1348 - LEE'S SUMMIT

NEW GROUND UP AND DRIVE THRU OF QUICK SERVICE RESTAURANT

FIELD NOTICE #3: 2021-08-09

FOOTING DETAIL - LED BOLLARD

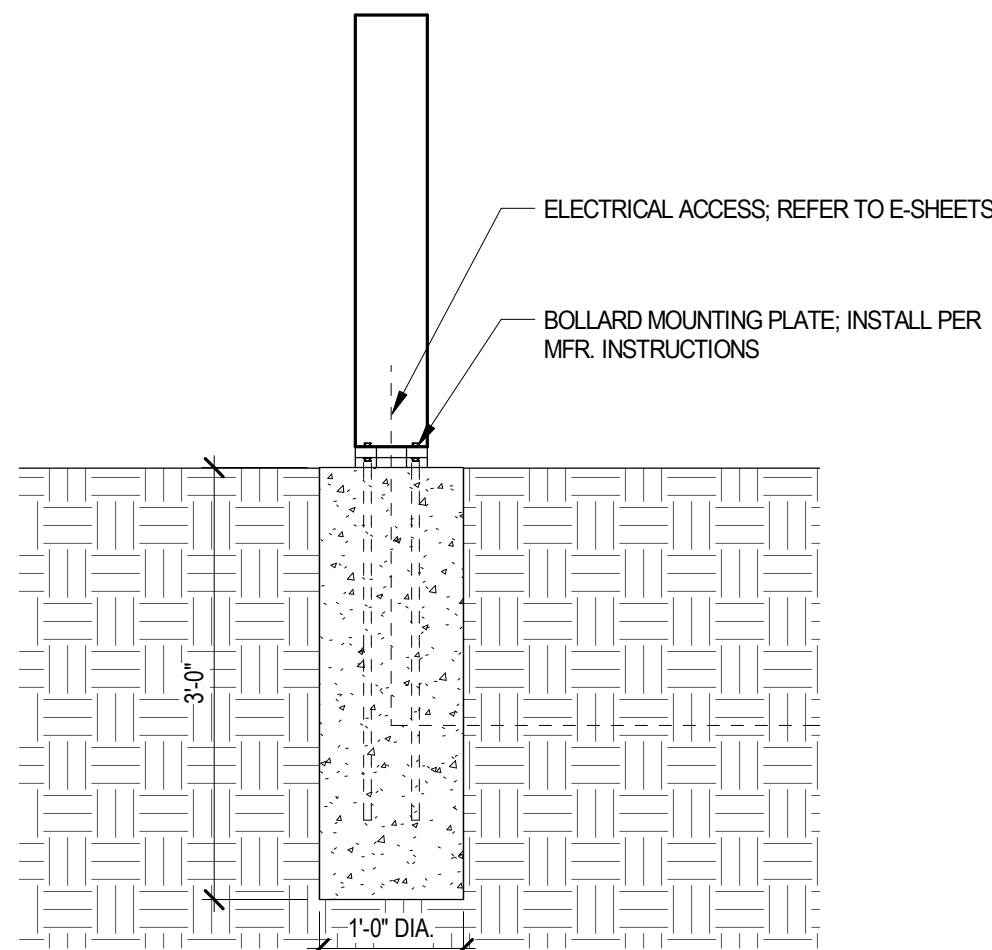
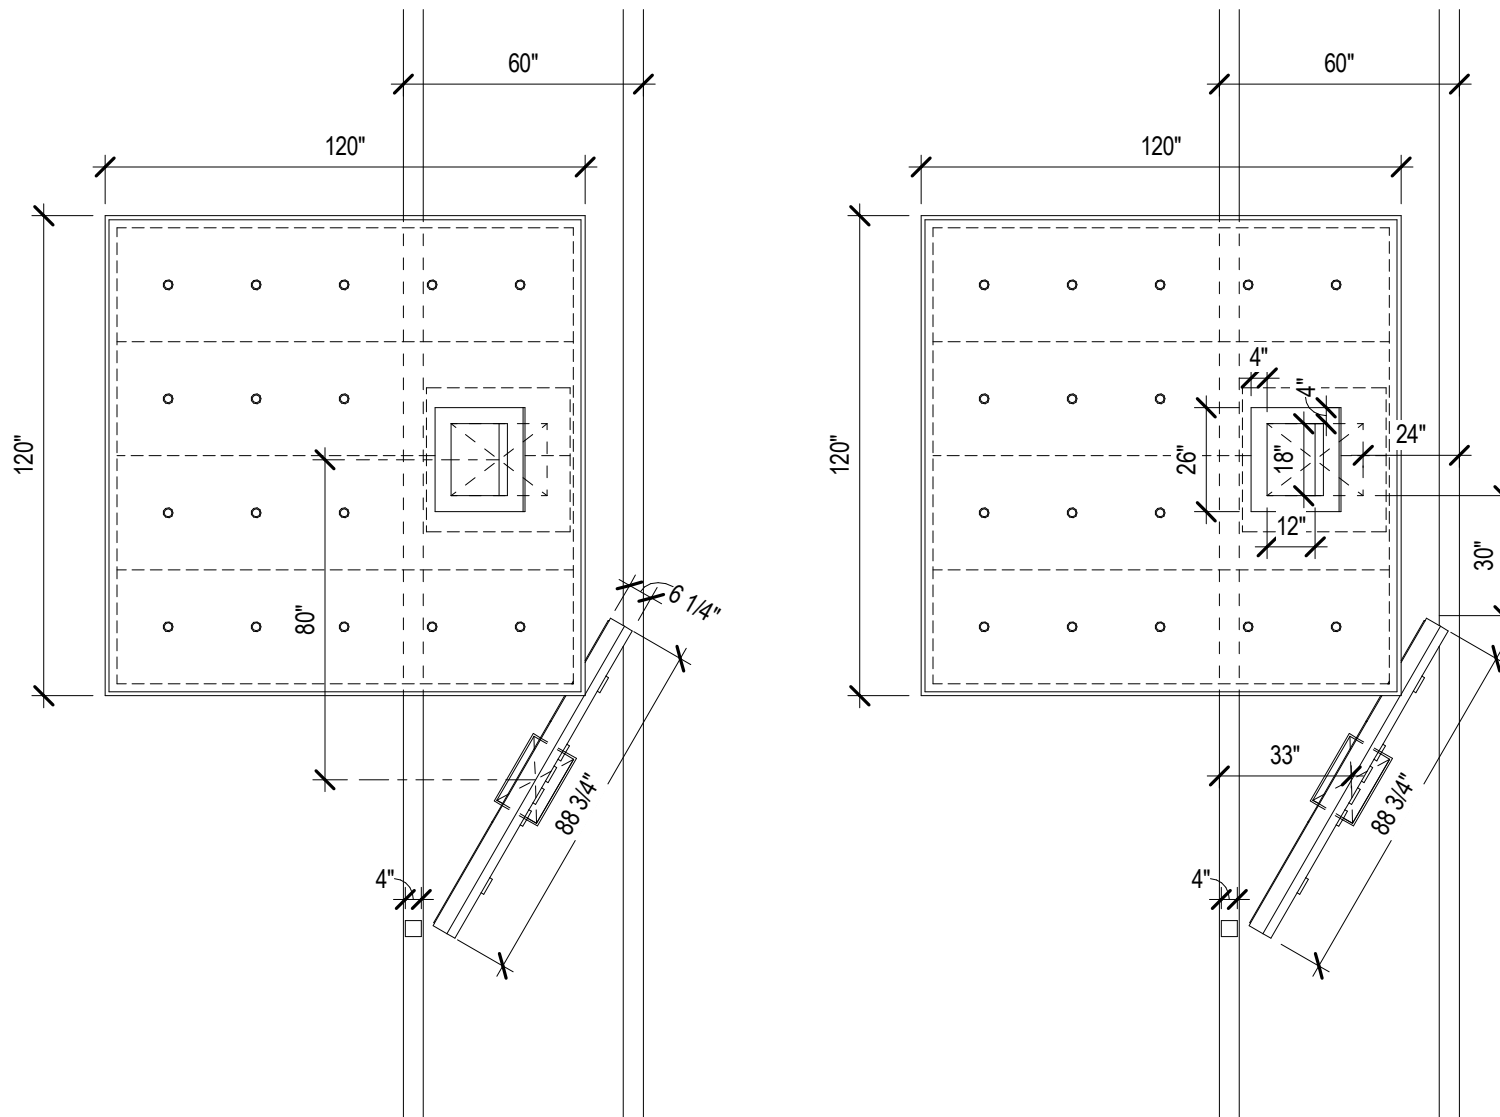
- 19 AREA OF ADDITIONAL STRIPING, REF: TO CIVIL
- 20 DRIVE-THRU PULL AHEAD DEDICATED PARKING SPACES
- 21 NO MESH TO BE PLACED UNDER CONCRETE PAD
- 22 NEW ASWAY THREE ILLUMINATED BOLLARDS, BLACK BOLLARD TO BE OFFSET 18-24" FROM CURB, TYP. REF: TO DETAIL 4/AS101 FOR MOUNTING INFORMATION, REF: TO ELECTRICAL, CIVIL
